Appendix: Previously Reviewed Baseline Upgrade Recommendations for the September 2020 PJM Board Review

Existing b2900 Cost Increase and Scope Modification

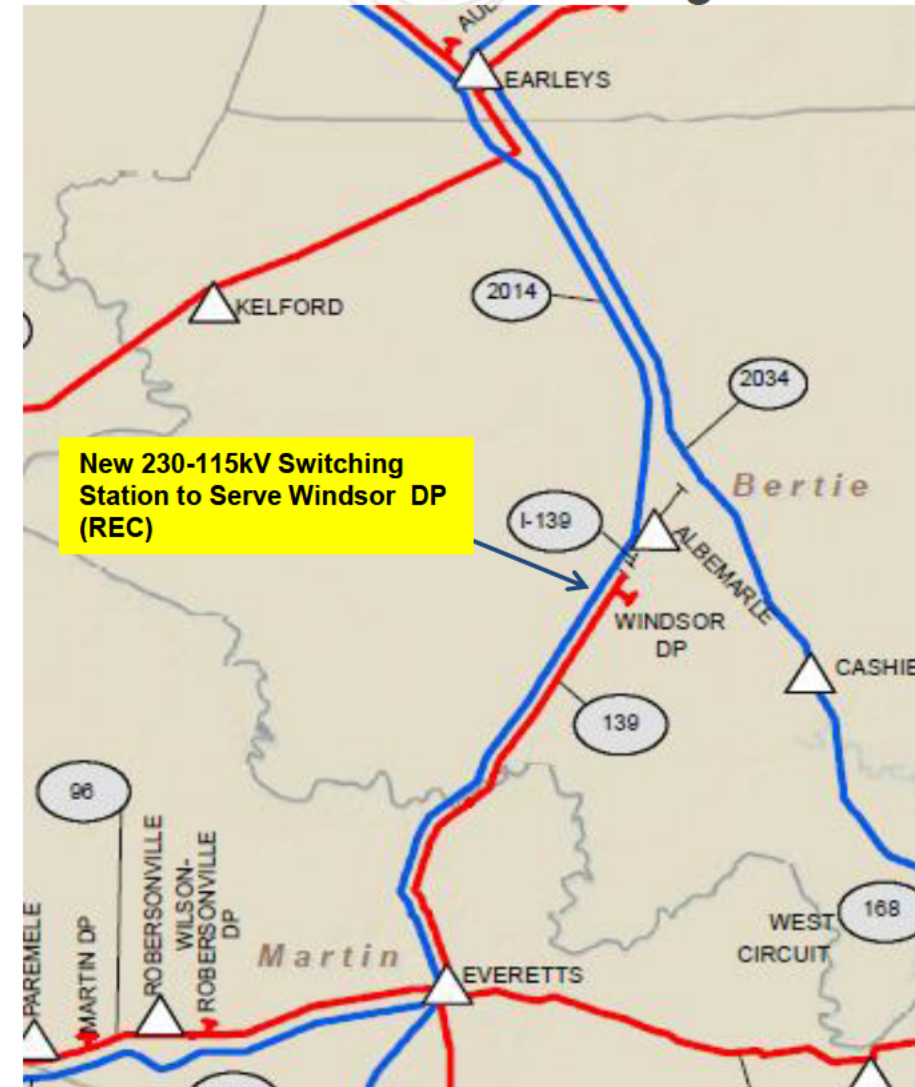
- Build a new 230-115kV switching station connecting to 230kV network Line #2014 (Earleys – Everetts). Purchase land and install three single phase 30 MVA 230-115kV transformers (and a spare) with a high and low side breaker. Provide a 115kV source from the new station to serve Windsor DP. Remove Line #139 19.5 miles (15.5 miles Everetts – Windsor, 1.1 mile Windsor to idle line, 2.9 miles idle line). **(b2900)**

- Build a new 230-115kV switching station connecting to 230kV network Line #2014 (Earleys – Everetts). Purchase land and install (2) three phase 84 MVA 230 -115kV transformers (one serve as a spare) with a high and low side breaker. Provide a 115kV source from the new station to serve Windsor DP. Remove Line #139 19.5 miles (15.5 miles Everetts – Windsor, 1.1 mile Windsor to idle line, 2.9 miles idle line).

- **Original Estimated Project Cost:** \$11.5 M
- **Revised Estimated Project Cost:** \$17.4 M **New**

B2767 Scope change:

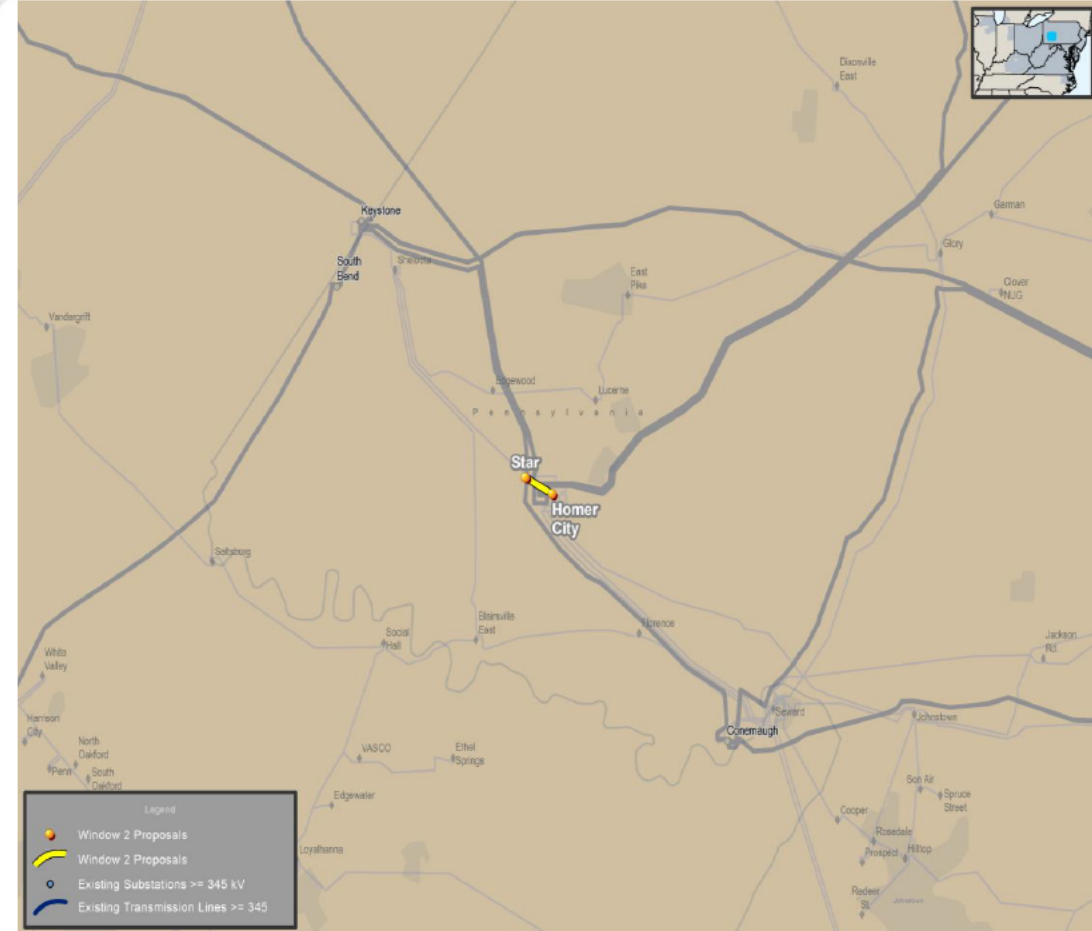
The Homer City 345/230 kV transformer “S” is overloaded for a line fault stuck breaker contingency loss of the Homer City – Armstrong 345 kV circuit and Homer City 345/230 kV transformer #N.

Construct a new 345kV breaker string with three (3) 345kV breakers at Homer City and move the North autotransformer connection to this new breaker string. (2016_2-8G)

Install one new 345 kV breaker and relocate the Homer City - Mainesburg 345 kV line terminal and Homer City 345/230 kV North transformer terminal

Baseline Scope change: B3100, Previously presented in 1/11/19 and 2/20/19 SRRTPEP

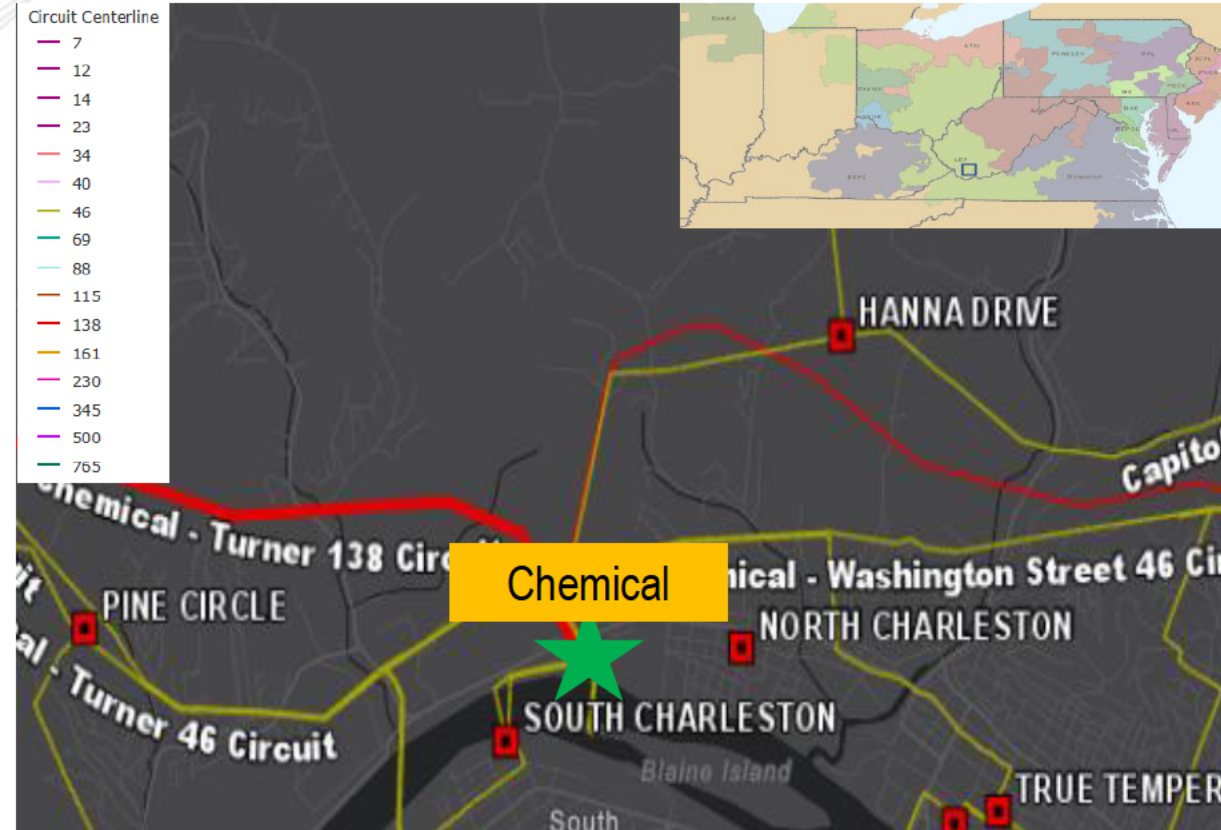
Planning Criteria Violations: In the 2022 PJM Winter RTEP, a TO Criteria violation was identified due to exceeding the thermal emergency rating (106% of the 66 MVA thermal emergency rating) on Chemical transformer #2 under a N-1-1 contingency condition involving the loss of the Chemical transformer #6 (which includes the loss of XFR #4, Chemical – Turner 138 kV line and Chemical – Ortin 138 kV, due to the loss of 138 kV bus #1) paired with the loss of the Capitol Hill – Chemical 138 kV line (which includes the loss of XFR #1, due to it's existing configuration on the line).

~~Replace 138kV MOAB switch "YY" with a new 138kV circuit switcher on the high side of Chemical XFR #6.~~

Relocate 138 kV circuit breaker W between 138 kV bus #1 extension and bus #2. Install a new 138 kV circuit breaker between bus #1 and bus #1 extension.

Reason for the change: The baseline solution was re-visited as AEP completed engineering for the supplemental solution (AEP-2018-AP018 and AEP-2019-AP010). Instead of installing a switcher only on the high side of the transformer, AEP installs a breaker in series with existing breaker W to create another high side bus to serve the 138/46 kV transformer. The cost is the same; it only affects the layout of the high side of the station. As outlined in the ancillary benefits though, it allows for much greater operational flexibility.

Baseline Scope Change: B3116, Previously presented 2/20/19 and 5/20/19 in SRRTEP

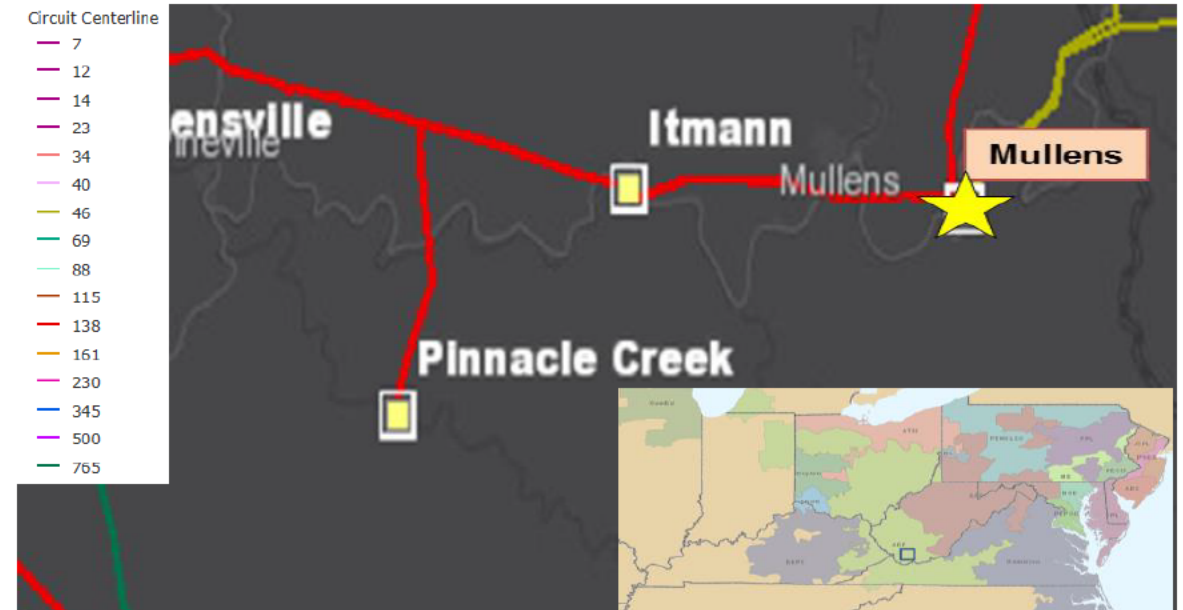
Planning Criteria Violations: In the 2022 PJM Winter RTEP, TO Criteria violation due to exceeding thermal emergency rating (105% of the 35 MVA thermal emergency rating) on Mullens 138/46 kV transformer #4 under N-1-1 contingency condition involving the loss of the Bradley – Jehu Branch 138 kV line plus the loss of the Tams Mountain – Mullens 138 kV line.

Replace existing 138/46kV 30 MVA transformer #4 and associated protective equipment with a with a new 138/46 kV 90 MVA transformer and associated protective equipment. **Install required high side transformer protection by replacing the existing ground switch MOAB with a new 138 kV high side circuit breaker.**

Total Estimated Transmission Cost: ~~\$3.0M~~ \$4.0M

Reason for the change: It's a scope clarification to include that piece of the baseline solution. When replacing the transformer, the existing high side ground switch MOAB will also be replaced with a circuit switcher. This is considered baseline work because it is required with the replacement of the transformer.

Baseline Project Cancellation: B2594, Previously presented in 1/7/15 TEAC

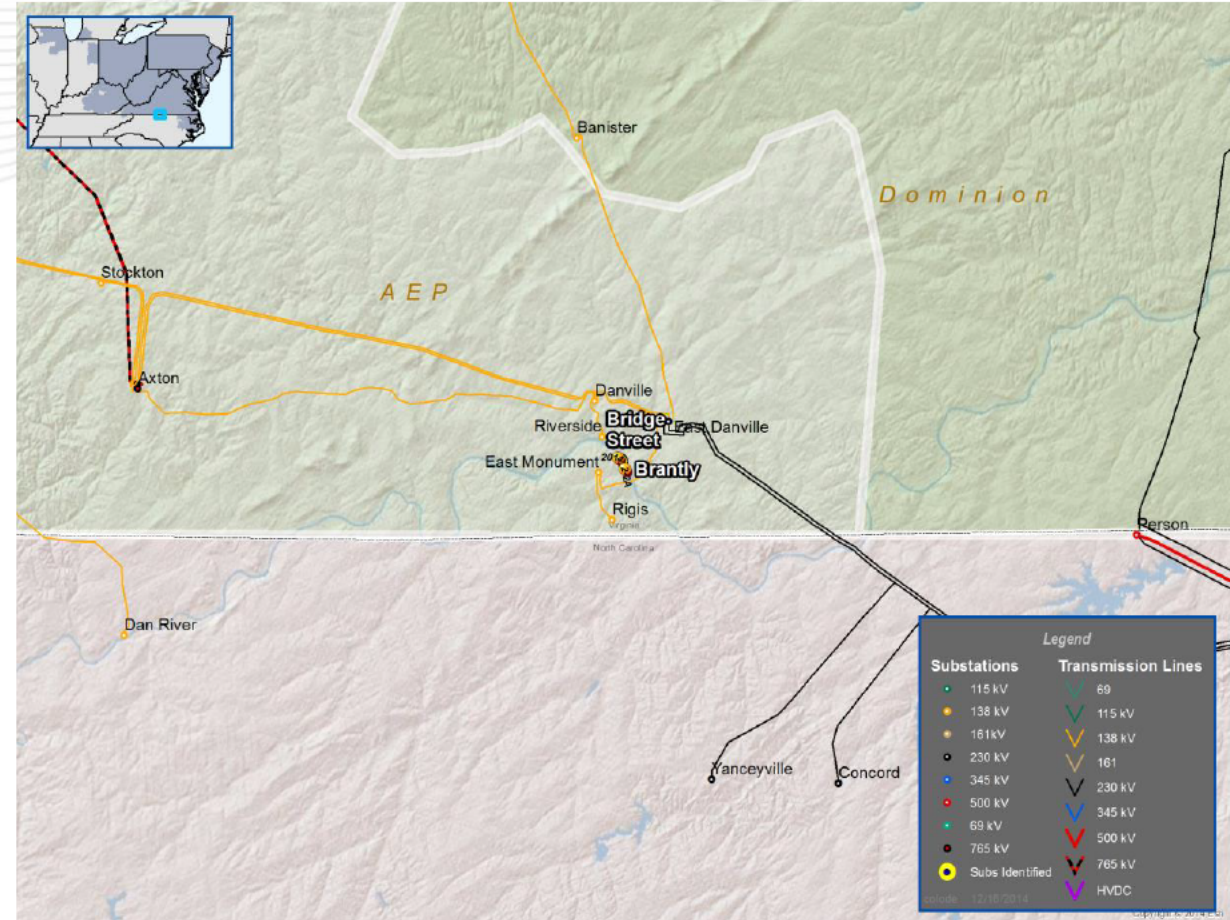
TO criteria violation: The Brantly – Bridge S 69KV line is overloaded for the loss of Danville – Riverside 138kV line

Rebuild 1.0 mile of Brantly-Bridge Street 69 kV Line with 1033 ACSR overhead conductor. (P2014_2-2A)

Reason for the Cancellation: The line is entirely owned by Danville, not AEP. This is not a PJM tariff facility.
